October 22, 2020
GO2-20-127

**Subject: COLUMBIA GENERATING STATION, DOCKET NO. 50-397
RESPONSE TO REQUEST FOR ADDITIONAL INFORMATION RELATED
TO FOURTH TEN-YEAR INTERVAL INSERVICE INSPECTION (ISI)
PROGRAM RELIEF REQUEST 4ISI-09**

RESPONSE TO REQUEST FOR ADDITIONAL INFORMATION

Figure A
Sketch of N4 Feedwater Nozzle Assembly

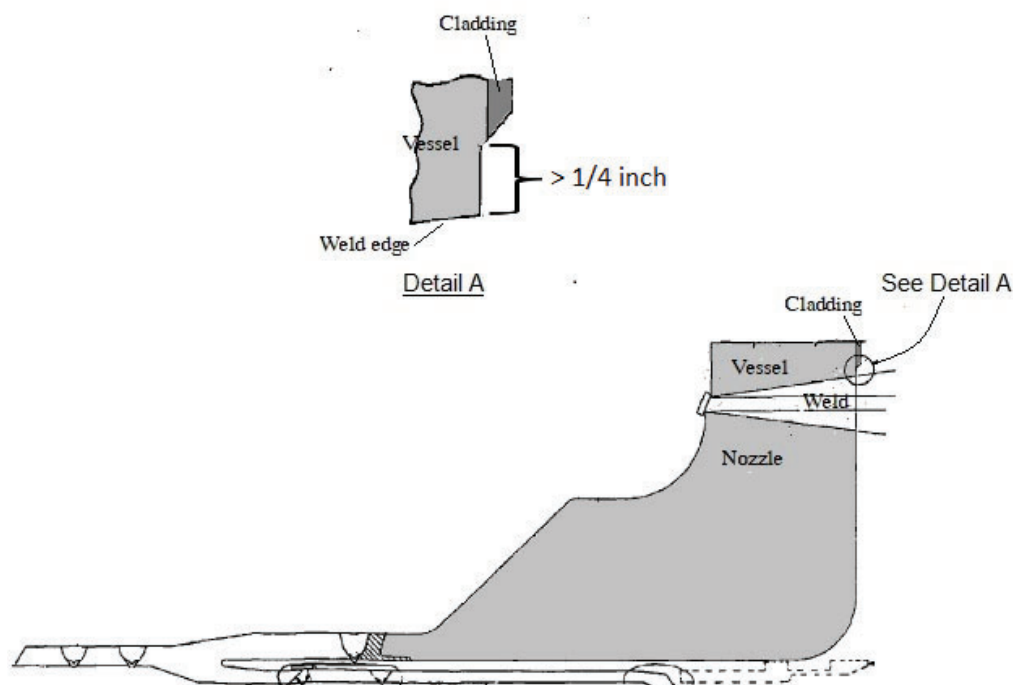
First paragraph on Page 5 of the relief request states that the cladding on the feedwater nozzle inner radius has been removed. However, Enclosure 2 to the licensee's April 22, 2020 letter does not specifically mention that cladding is not modeled on the nozzle radius in the finite element analysis. Also, the relief request does not include a drawing to show location of the cladding on the reactor vessel shell that near the nozzle inner radius. The NRC staff notes that the location of cladding is significant because thermal expansion of cladding is different from that of the reactor vessel shell.

- (a) Confirm that the finite element model in Enclosure 2, Figure 3 does not include cladding on the inner surfaces of feedwater nozzles and associated nozzle-to-shell welds. If there is no cladding on the nozzle-to-shell welds, justify that the clad stress due to the thermal expansion difference between the clad and the reactor vessel shell of the adjacent cladded inner surface shown in Figure 3 has negligible impact on stresses in the nozzle-to-shell welds.
- (b) Provide a sketch to show the distance from the feedwater nozzle or nozzle-to-shell weld to the reactor vessel shell that has no cladding.
- (c) Confirm that the finite element model of the feedwater nozzle radius and nozzle-to-shell weld is consistent with the actual field configuration.

- a) It is confirmed that the finite element model in Enclosure 2, Figure 3 did not include cladding on the inner surfaces of feedwater nozzles and associated nozzle-to-shell welds. In Figure 3 of Enclosure 2, the leftmost figure shows the cladding as a thin blue layer relative on the inside surface of the RPV base metal, which is shown in red. Because the cladding was explicitly included in the model, the clad stress due to the thermal expansion difference between the cladding material and the reactor vessel shell material was accounted for in the finite element analysis.
- b) Figure A below provides a sketch based on the N4 Nozzle Assembly drawing, 02B13-06,141 Revision 10, the distance from the outside edge of the nozzle-to-shell weld to the edge of the cladding is greater than $\frac{1}{4}$ inch.

- c) It is confirmed that the finite element model of the feedwater nozzle radius and nozzle-to-shell weld was consistent with the actual field configuration, as shown in the sketch in RA12.1(b) above.

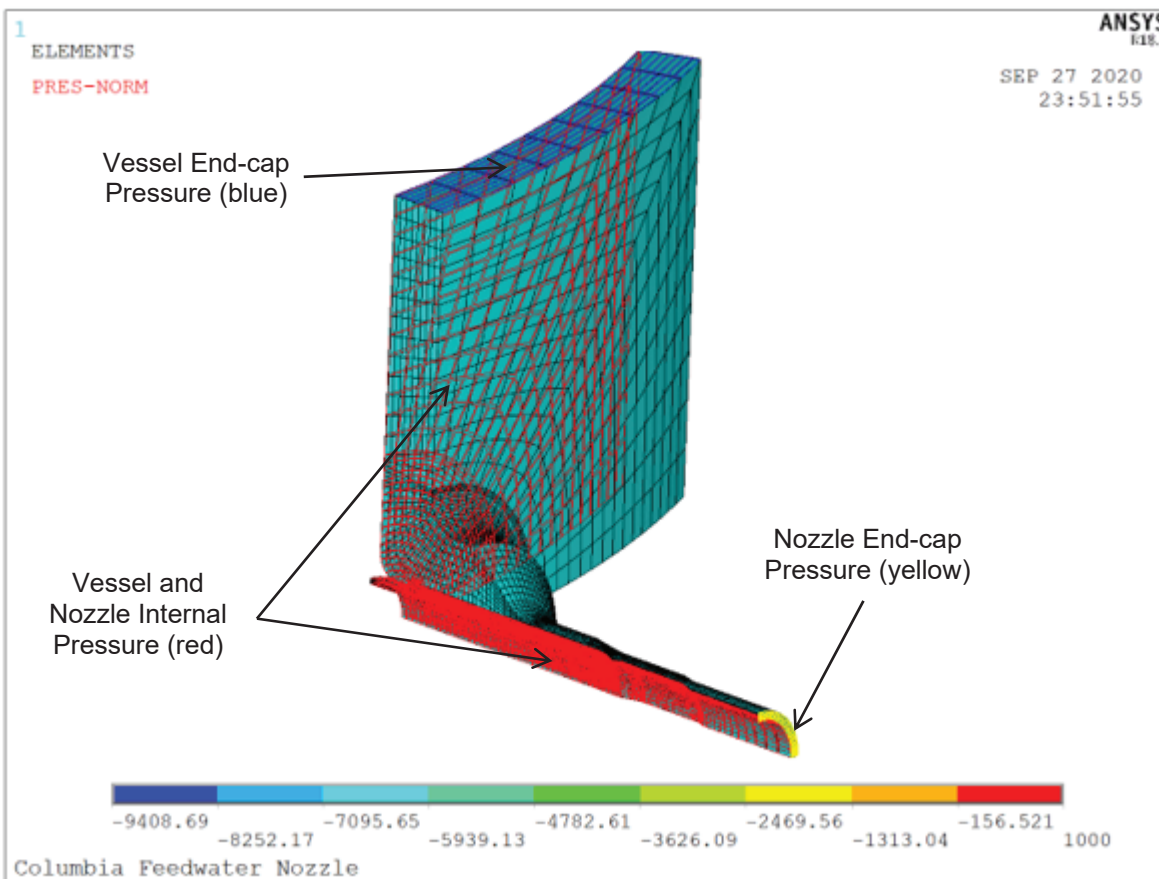
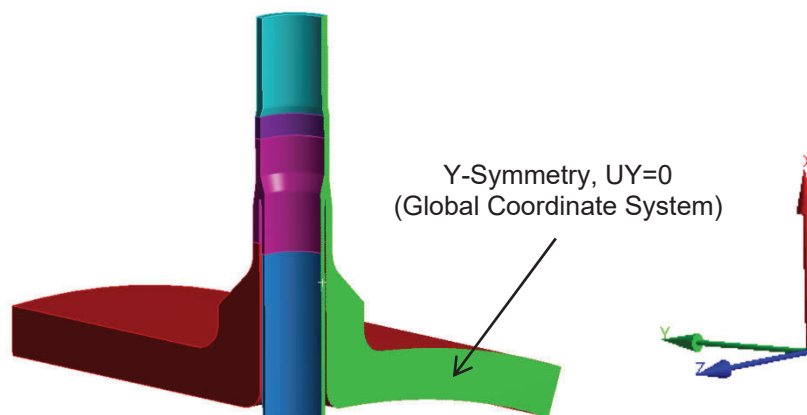
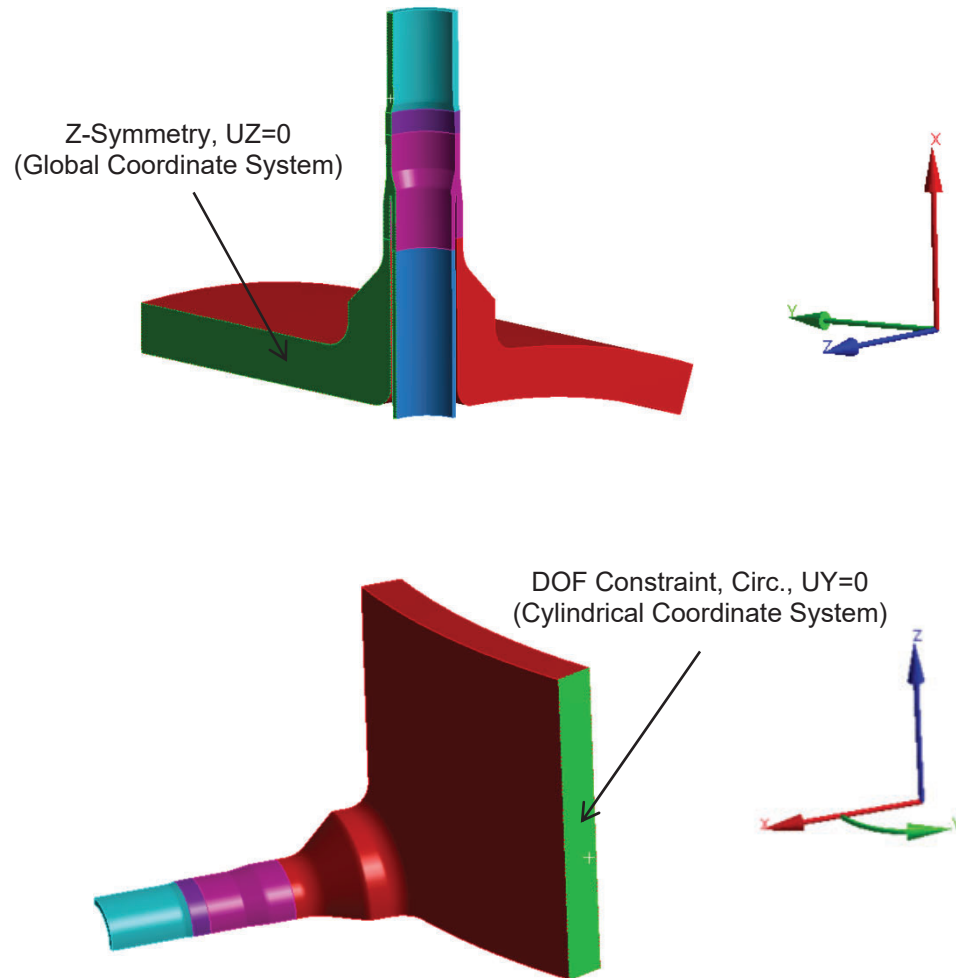
Enclosure 2, Figure 4 is labeled as the applied pressure and boundary conditions. However, the NRC staff is not clear exactly what are the applied pressure and boundary conditions in Figure 4.

Clarify what are the pressure and boundary conditions that are applied to the finite element model as shown in Figure 4.

Using the finite element model from the evaluation, Figure 4 of Enclosure 2 has been replotted from a different perspective to more clearly show the applied internal pressure and end-cap pressures, as discussed in Section 4.1.2 of Enclosure 2I:

Using the finite element model from the evaluation, the following figures show the applied boundary conditions separately:

Nozzle Corner Crack Model from pc-CRACK 4.3

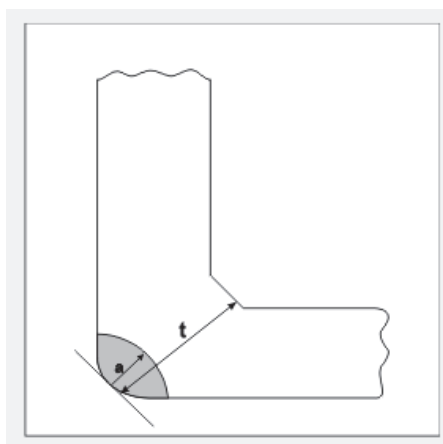
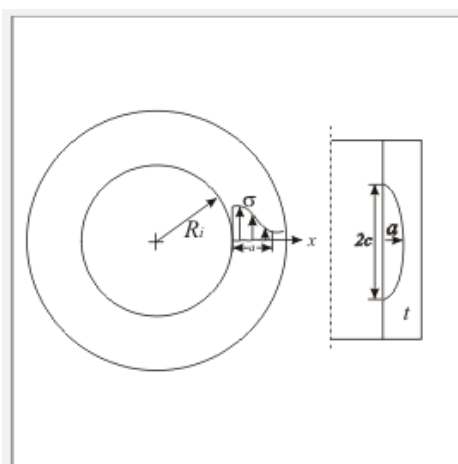
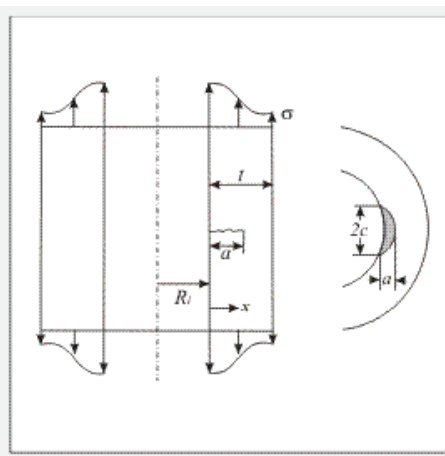
- (b) Discuss how the axial flaw and circumferential flaw are modeled in the nozzle radius and nozzle-to-shell weld in the DFM evaluation for CGS. Specifically, discuss the initial flaw size and the direction of the axial and circumferential flaw propagation in the nozzle radius and nozzle-to-shell weld.

- b) For path locations P1 and P2, the model is semi-circular nozzle corner crack with a given initial depth (See in the figure below). The cracks are modeled to propagate from the inside blend radius at the smallest distance between the inner and outer blend radius.

The crack-models are semi-elliptical axial crack for path locations P3, P4, and P5 while the crack model is a semi-elliptical circumferential crack for path location P6. They are developed from the inside surface of a cylinder with a given initial depth and length. The cracks are propagated through the cylinder wall thickness from the inside radius to outside radius in depth and length with a fixed aspect ratio. Refer to the figure below for the axial and circumferential crack models used in pc-CRACK 4.3.

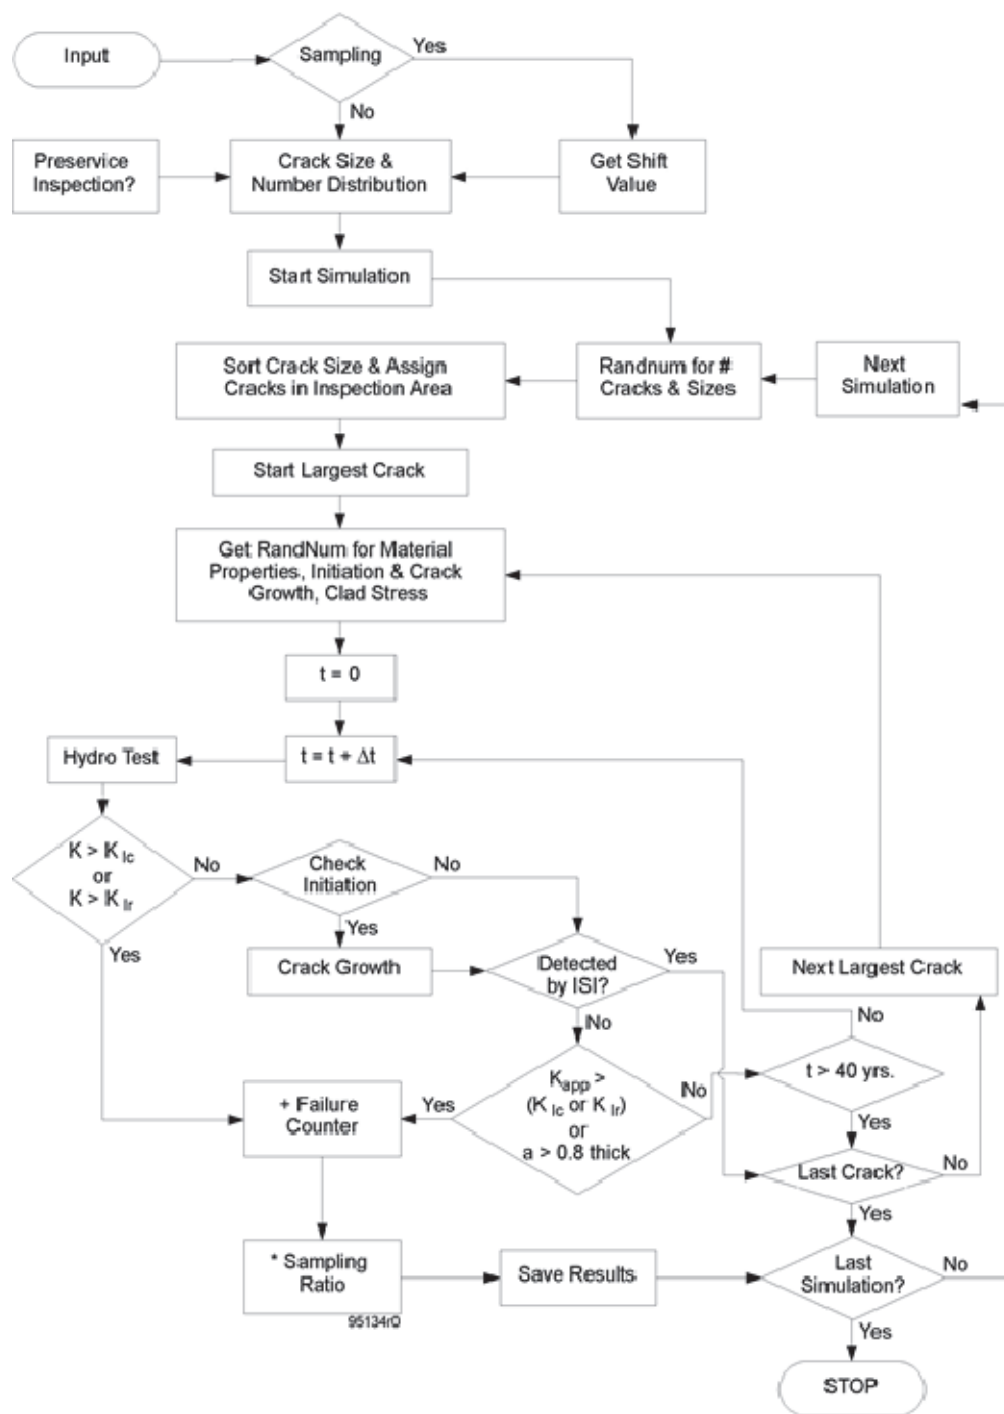
The NRC staff notes that Figure 8-1 of BWRVIP-05 provides an overview of the PFM analysis methodology. Figure 8-11 of BWRVIP-05 provides a flow diagram of the computer code VIPER. Enclosure 2 states that it follows the PFM methodology in BWRVIP-05, BWRVIP-108-A, and BWRVIP-241-A. However, it is not clear to the NRC staff exactly how the PFM evaluation in Enclosure 2 was performed.

- (a) Discuss whether the PFM evaluation in Enclosure 2 is similar to the flow diagrams in BWRVIP-05. If there are differences, provide a flow diagram that explains the methodology in the PFM evaluation in Enclosure 2.
- (b) Discuss how the stress paths in the stress analysis are used to derive the applied stress intensity factors.

- a) The PFM evaluation in Enclosure 2 follows the VIPER-NOZ flow diagram below, which is similar to the flow diagram in BWRVIP-05.
